PROJECT: Quest Academy

SUBMITTAL: 3rd

CITY OF LAS VEGAS		DATE:
INTER-OFFICE MEMORANDUM		November 1, 2012
TO: Land Development Services Department of Public Works		FROM: Albert Sung, P.E. Flood Control Project Engineer Department of Public Works
SUBJECT: Drainage Study for: Quest Academy		COPIES TO: DRC Surveying Nevada, Inc.
Cross Streets:	SWC Deer Springs Way & Grand Canyon Dr	Quest Academy
File Number:	F:\Depot\DSMemos\DS4572C.doc	Bart Anderson, P.E., DevCo
Parcel Number:	125-19-301-007 & 125-19-301-008	CCPW
Zoning Action:	SDR-46570; SUP-46572; SUP-46573 & PMP-46996	
FEMA Flood Zone	YES NO X	
Proposed Storm Drain	YES X NO

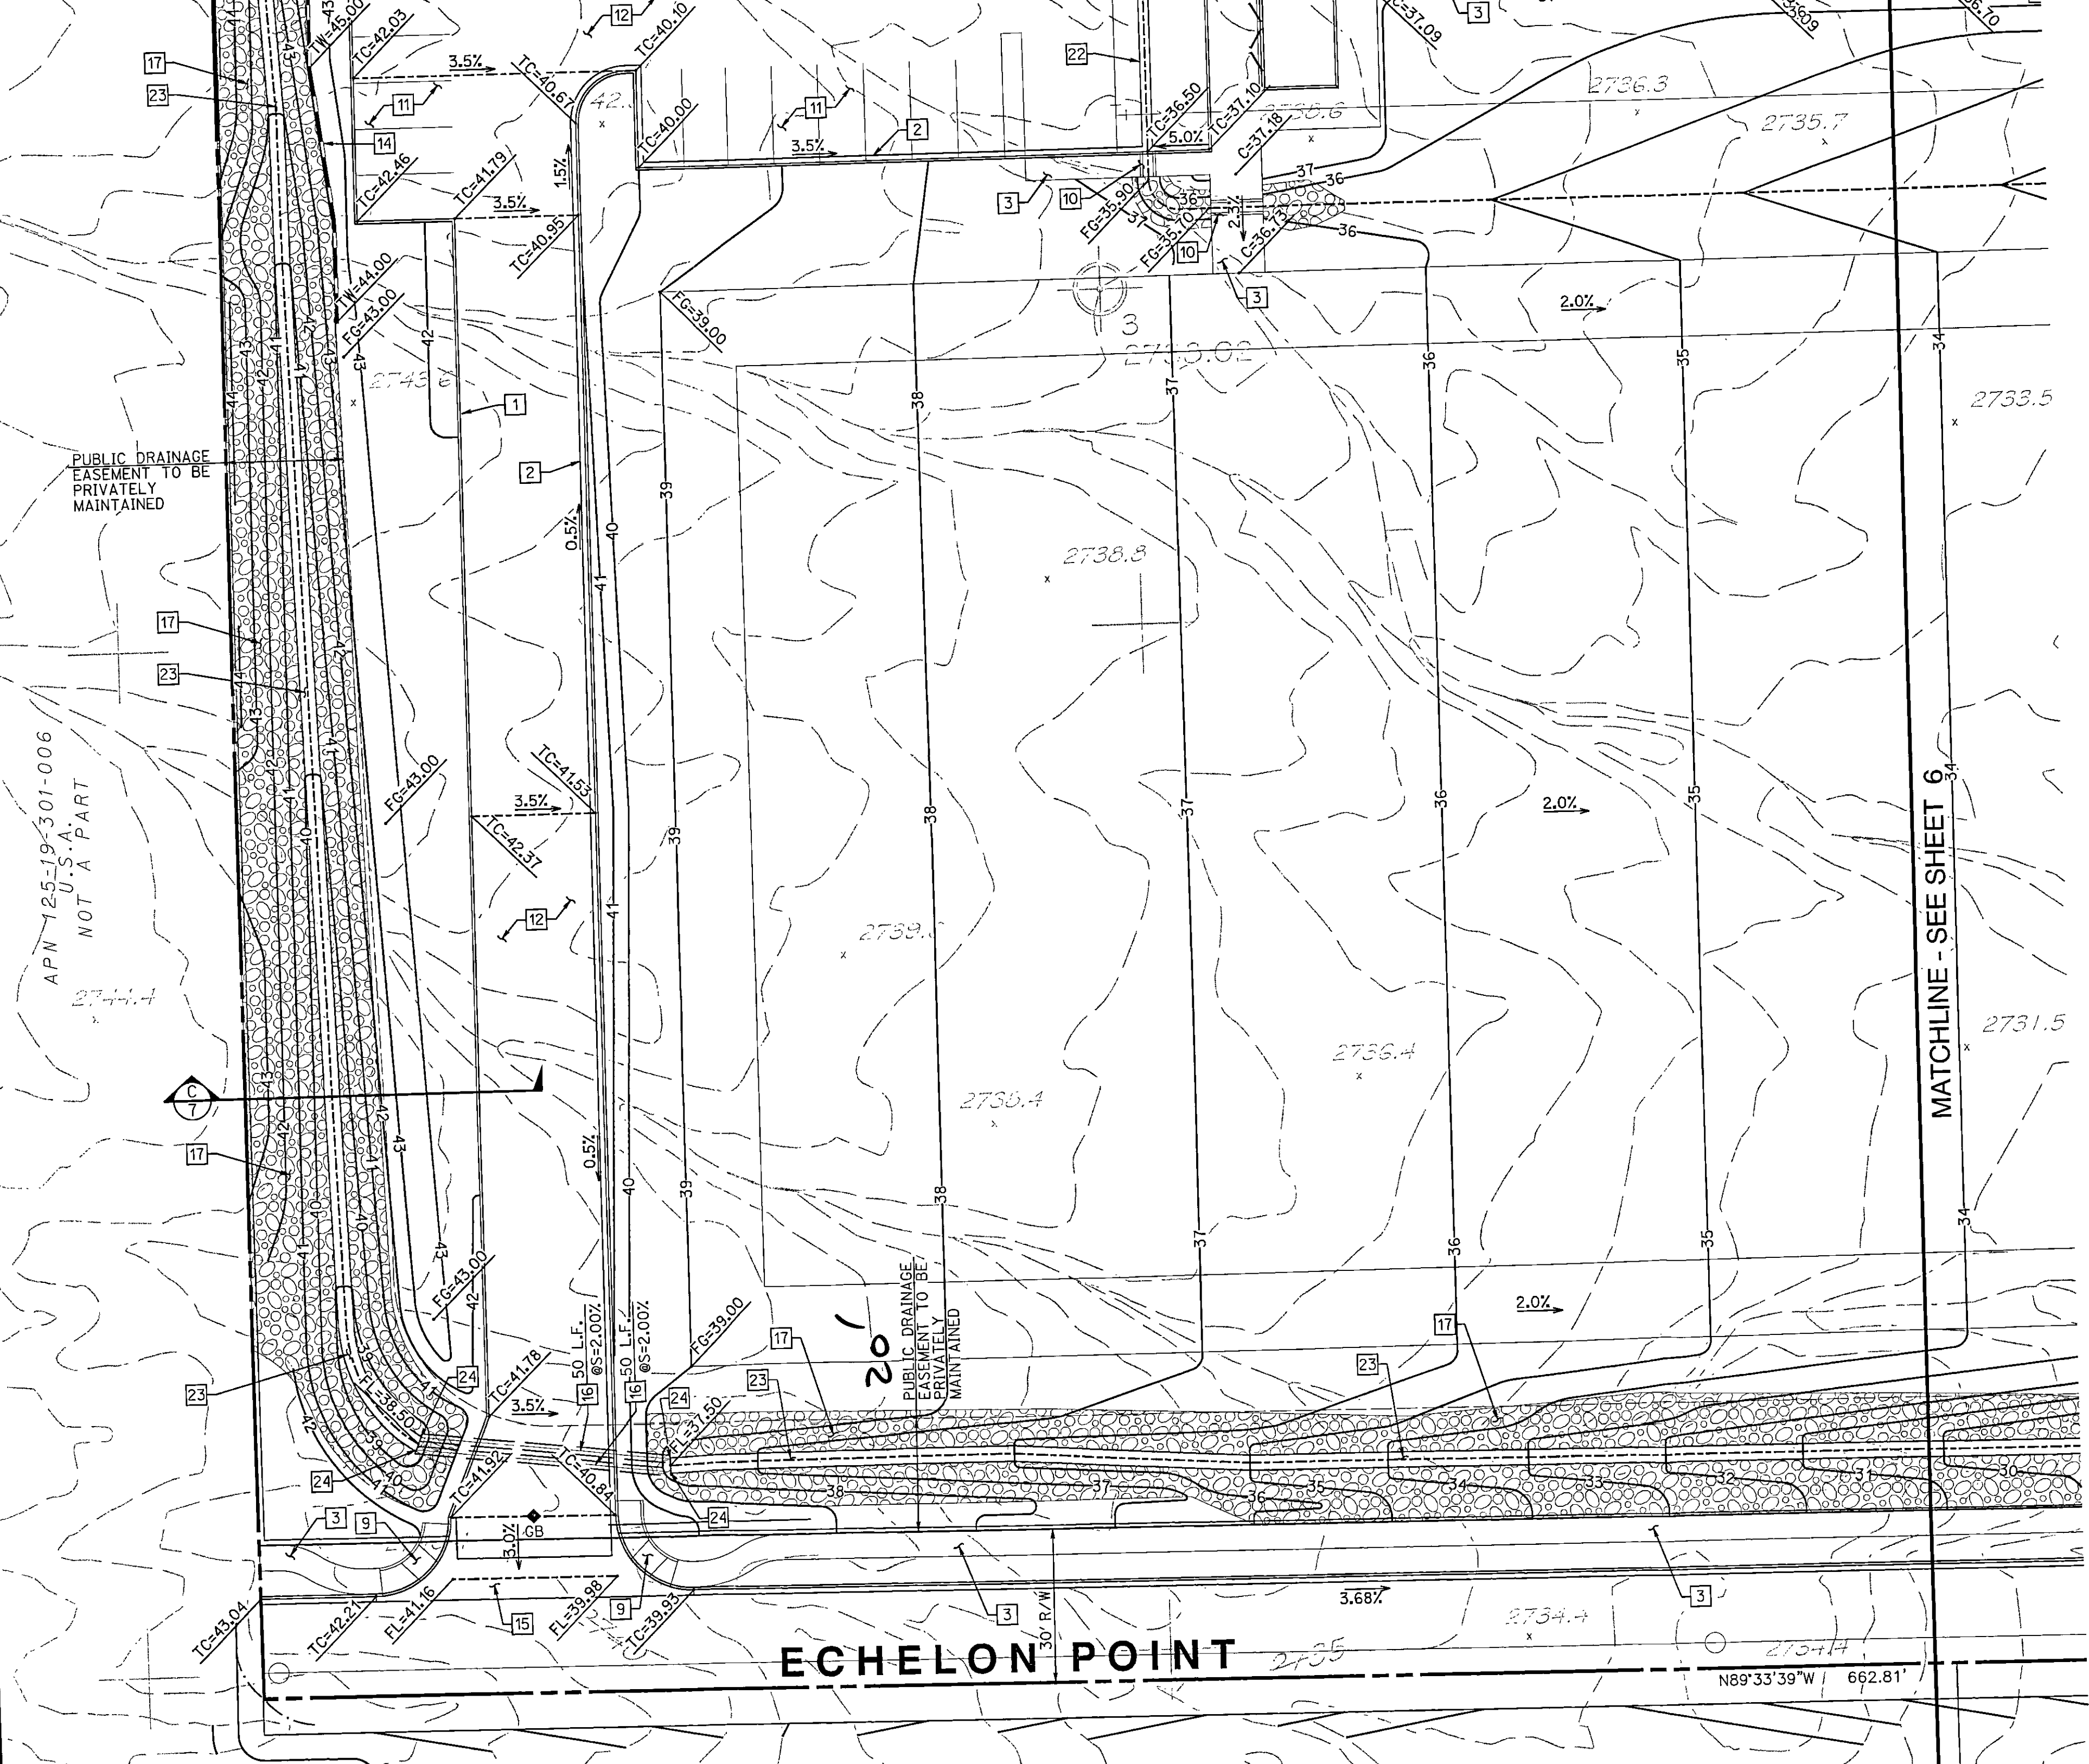
7. **Sheet 4 of 12 (Grading Plan):** Provide 2'-concrete valley gutter in flow lines where slope is less than 1%.

Extend an existing storm drain to the west in Deer Springs Way and provide a nuisance drop inlet at the BCR in Deer Springs.

Label the existing storm drain system with City of Las Vegas recorded drawing number on the plan.

Provide sidewalk underdrain at the proposed 2'-wide concrete flume in Grand Canyon Drive.

Sheet 4 was revised as follows: 1) 2-ft valley gutter is added in places where the slope is less than 1%, 2) a nuisance drop inlet and 18" storm drain lateral is provided in Deer Springs Way, 3) the existing storm drain system is labeled as requested, and 4) a sidewalk underdrain is provided at the proposed 2-ft wide concrete flume in Grand Canyon Drive.

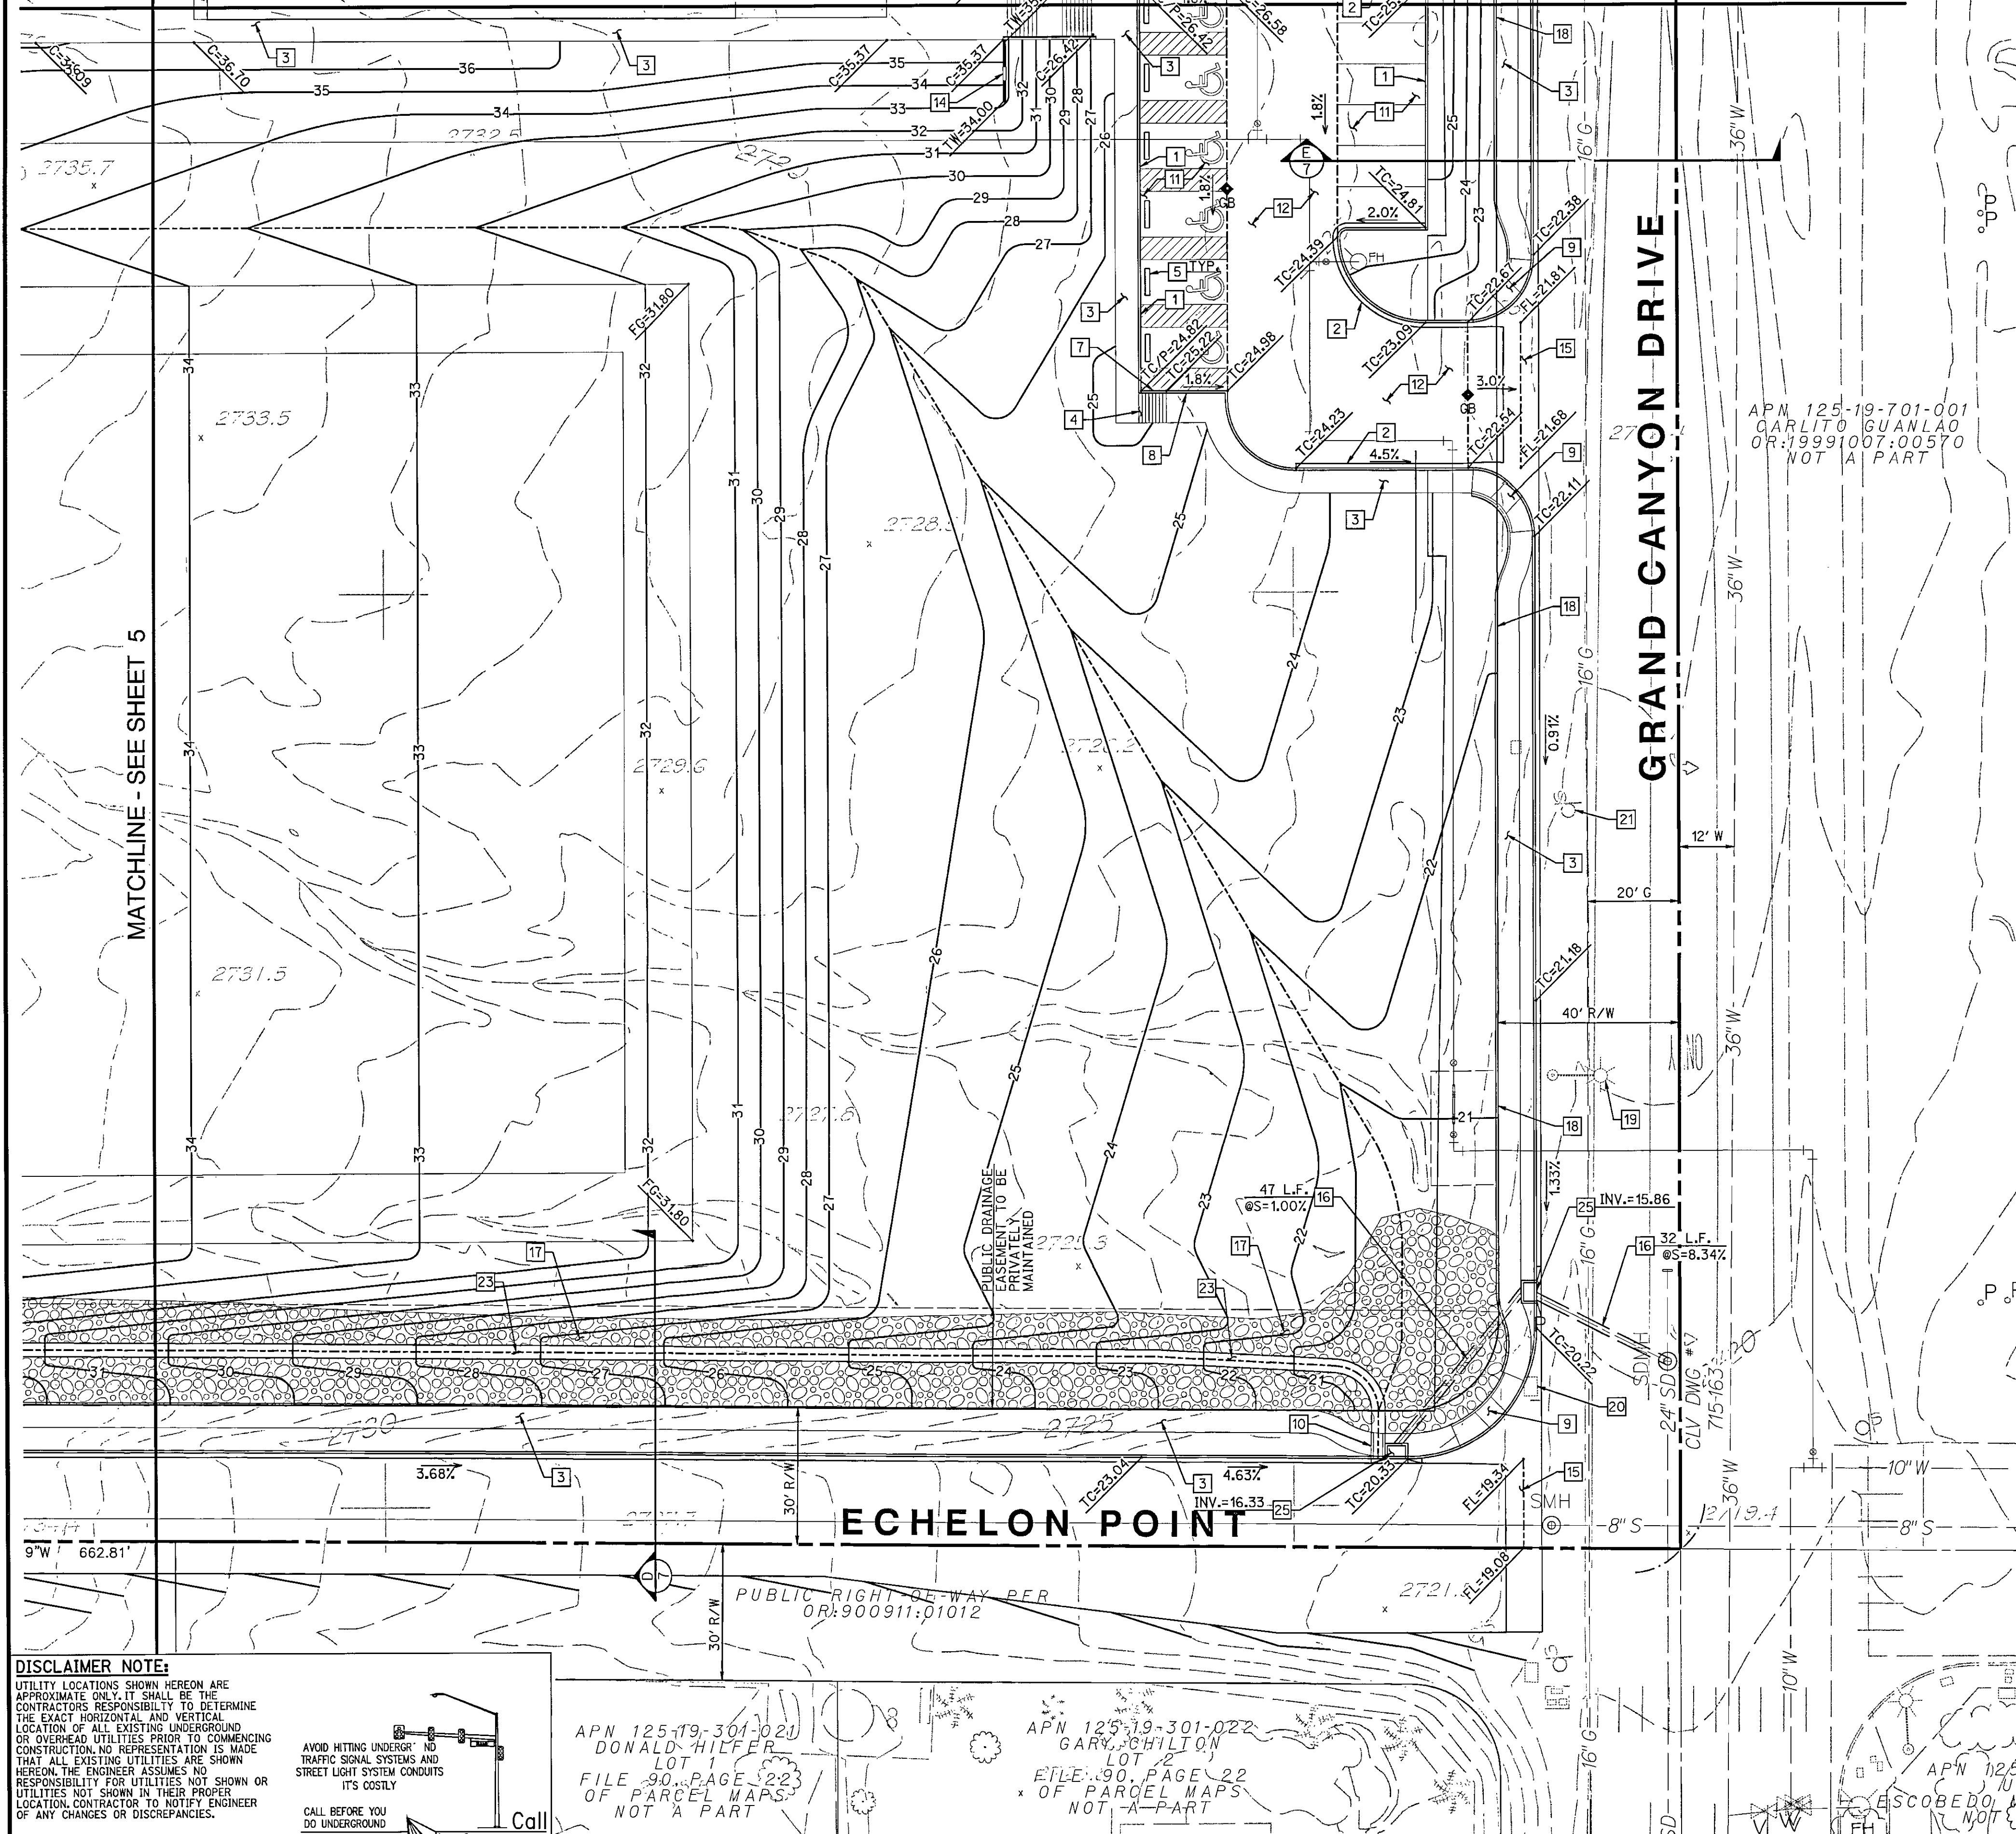
8. **Sheet 5 of 12 (Grading Plan):** Provide a 3'-valley gutter throughout the proposed riprap open channel.

Specify the number of 18" pipe at the driveway entrance on the plan and in the construction note column clearly.

Sheet 5 was revised as follows: 1) a 3-ft wide valley gutter is provided throughout the riprap section of the channel, and 2) a construction note is added to each pipe separately.

SHEET 6 OF 12
DRAWING NO.

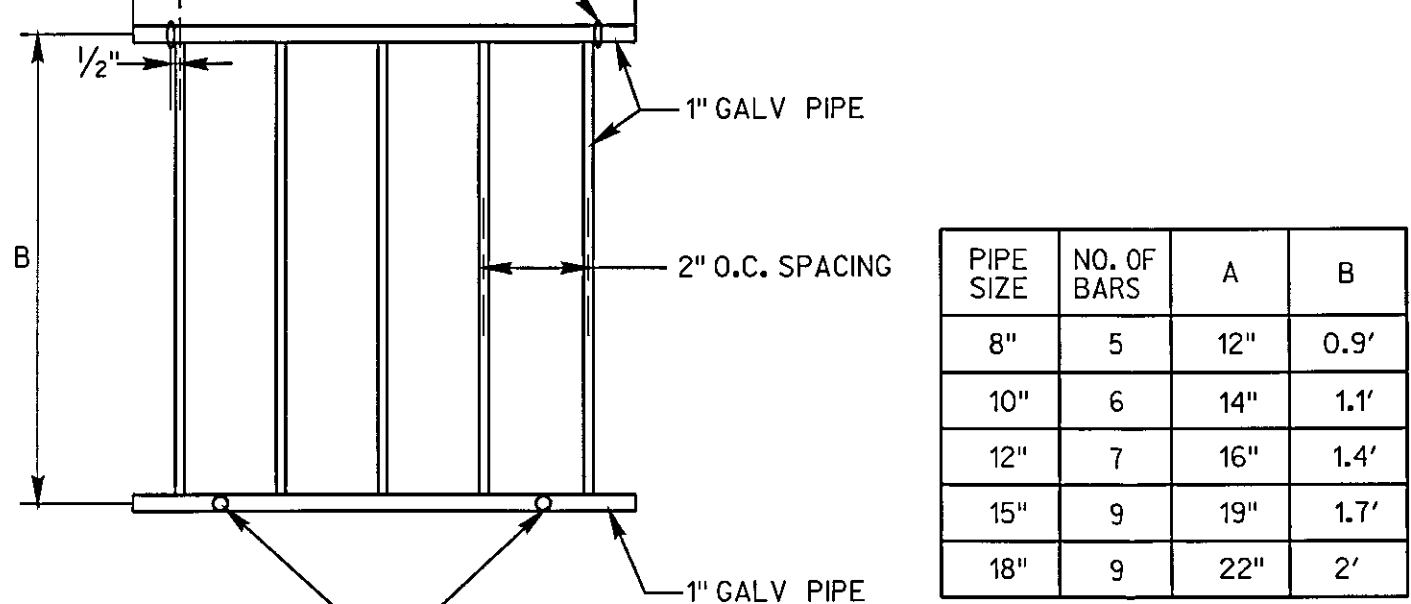
9. **Sheet 6 of 12 (Grading Plan):** See comment #8.

The engineer proposes to discharge a 100-year flow of 55 cfs in the riprap channel at the southeast corner of the development. However, this point discharge happens to impact a proposed water utility vault-like structure (a square shape on the plan) It is recommended to relocate this structure and a hydraulic calculation must be provided to obtain the discharge depth and velocity at the intersection of Echelon Point Drive and Grand Canyon Drive. Address the impact to the intersection under the current design in the next submittal.

Provide a nominal drop inlet at both the curb returns in Echelon Point Drive and Grand Canyon Drive. Connect the drop inlets and tie to the existing storm drain in the street.

channel so some flows will weir into Echelon Point upstream of the main discharge point thereby reducing the point impact. A flow depth calculation of the modified swale indicates that the capacity of the swale is reduced to 10 cfs just upstream of the discharge point. Combined with 6 cfs the point discharge is reduced to 16 cfs at the sidewalk underdrain upstream of the proposed inlet. Assuming the sidewalk underdrain has minimal flow capacity, most of the flow will sheet flow over the sidewalk. To get a rough idea of the flow characteristics over the sidewalk we did a normal depth calculation assuming a width of approximately 20' (see attached normal depth discharge calculation). The depth is approximately 0.2' with a velocity less than 4 ft/s.

Sheet 6 was revised to show two inlets and an 18-inch storm drain lateral per your request.

Sheet 6 was revised to show the existing 24-inch storm drain record drawing plan number.

A TYPICAL SECTION
N.T.S.

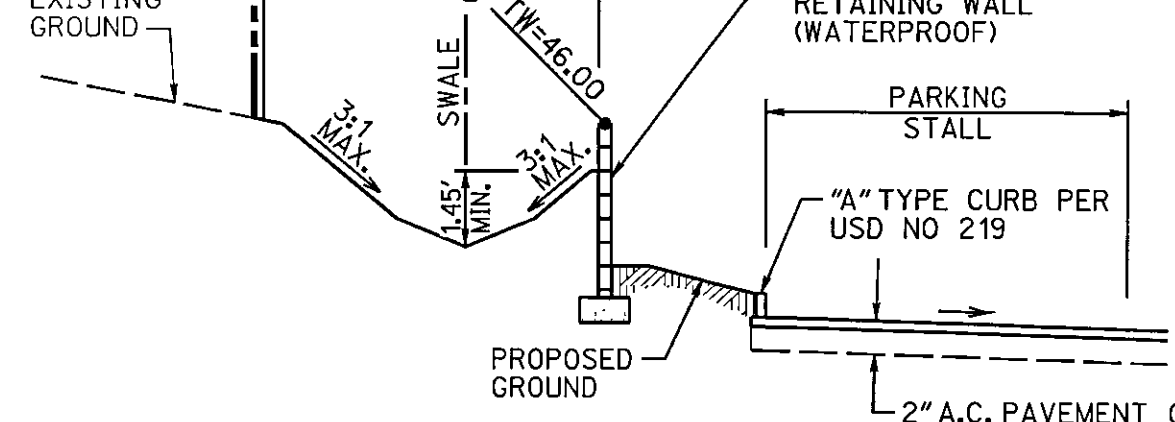
- 10. Sheet 7 of 12 (Detail & Cross-Sections): Typical Section A: A fence is proposed at the property line. What type of fence is this? Is it wrought iron fence or a block wall fence with wall openings? Please clarify.**

A wrought iron fence label was added to the detail.
